City of Portland, Maine – Building or Use Permit Application 389 Congress Street, 04101, Tel: (207) 874-8703, FAX: 874-8716

Location of Construction: 23 Fairview, Portland 04102		Owner: Marino, John J. Jr.		Phone: 828-1219		Permit No: 970988	
Owner Address:		Lessee/Buyer's Name:		Phone:		Business Name:	
Contractor Name:		Address:		Phone:		<div style="border: 2px solid black; padding: 5px; text-align: center;"> PERMIT ISSUED Permit Issued: SEP 15 1997 CITY OF PORTLAND </div>	
Past Use: Single fam		Proposed Use: Same/ deck added		COST OF WORK: \$ 1,000.00 FIRE DEPT. <input type="checkbox"/> Approved <input type="checkbox"/> Denied Signature:		PERMIT FEE: \$ 25.00 INSPECTION: Use Group: R3 Type: 516 Signature: <i>[Signature]</i>	
Proposed Project Description: Construct deck as per plans				PEDESTRIAN ACTIVITIES DISTRICT (P.A.D.) Action: Approved <input type="checkbox"/> Approved with Conditions: <input type="checkbox"/> Denied <input type="checkbox"/> Signature: _____ Date: _____			
Permit Taken By: Vicki Dover		Date Applied For: 9/5/97

BUILDING PERMIT REPORT

DATE: 12 Sept, 97 ADDRESS: 23 Fairview ST
REASON FOR PERMIT: To Construct deck
BUILDING OWNER: John J. Marino Jr.
CONTRACTOR

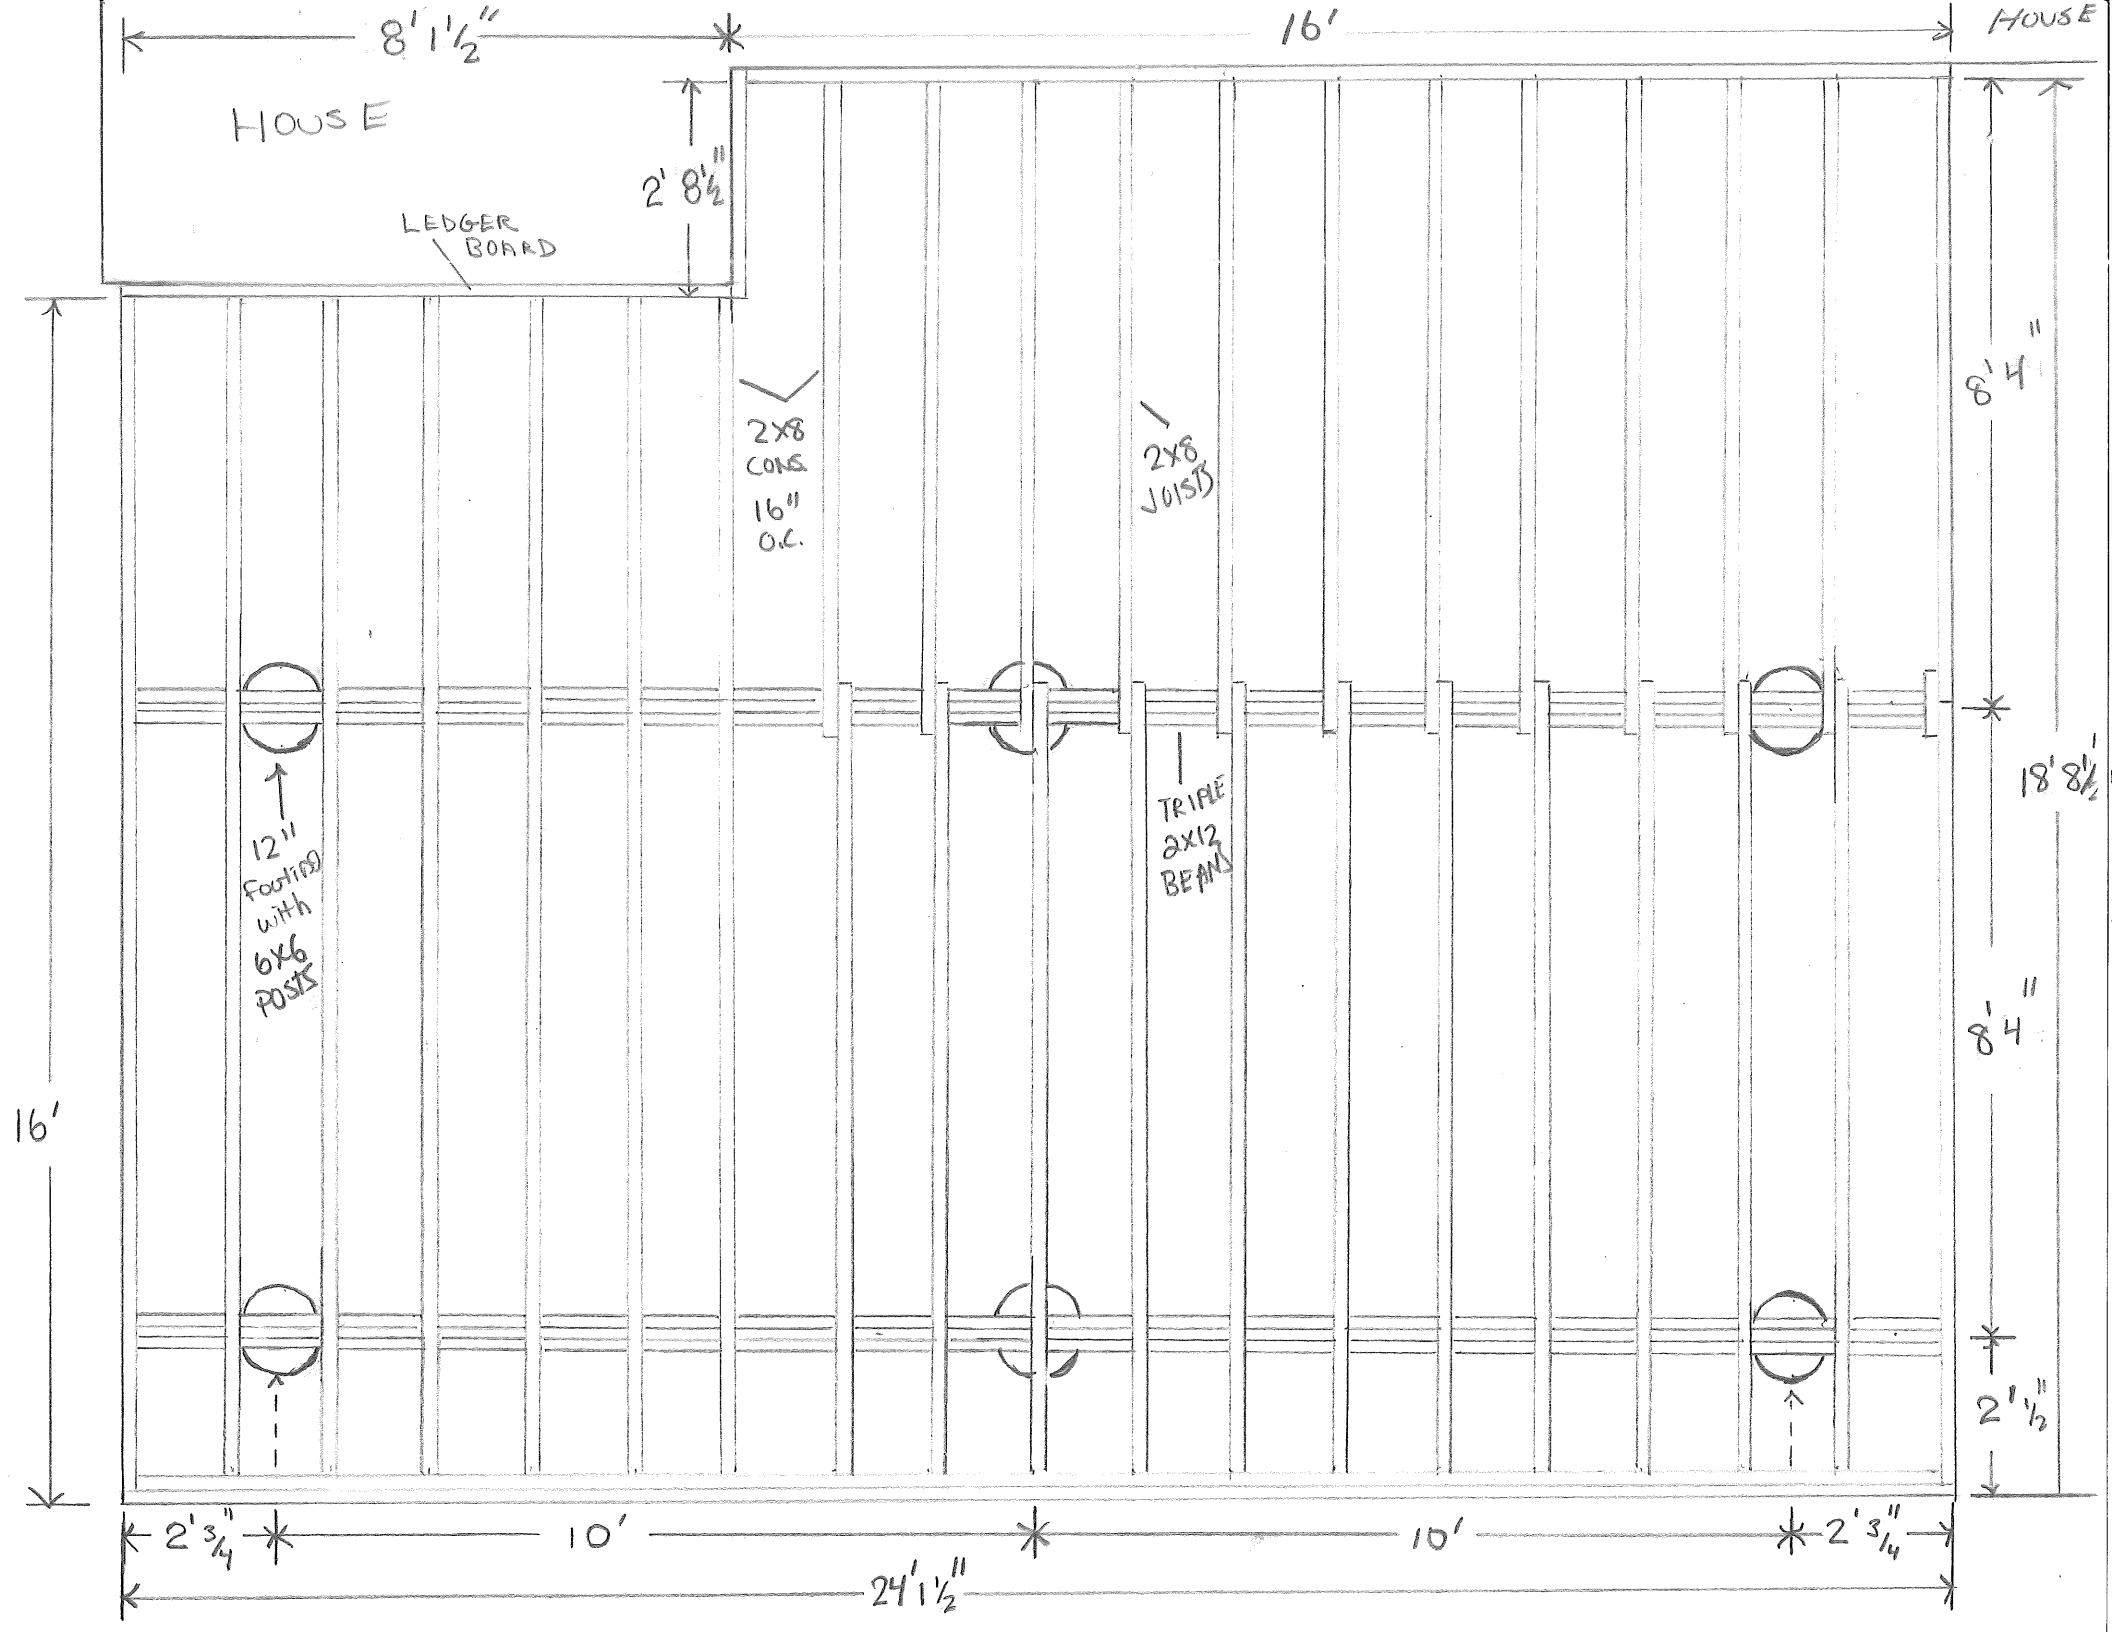
9-10-97 Sonar tubes checked have achieved 4'-0" depth on all.

Size - OK. OK to pour sonar tubes. 2x12 lag bolted to house.
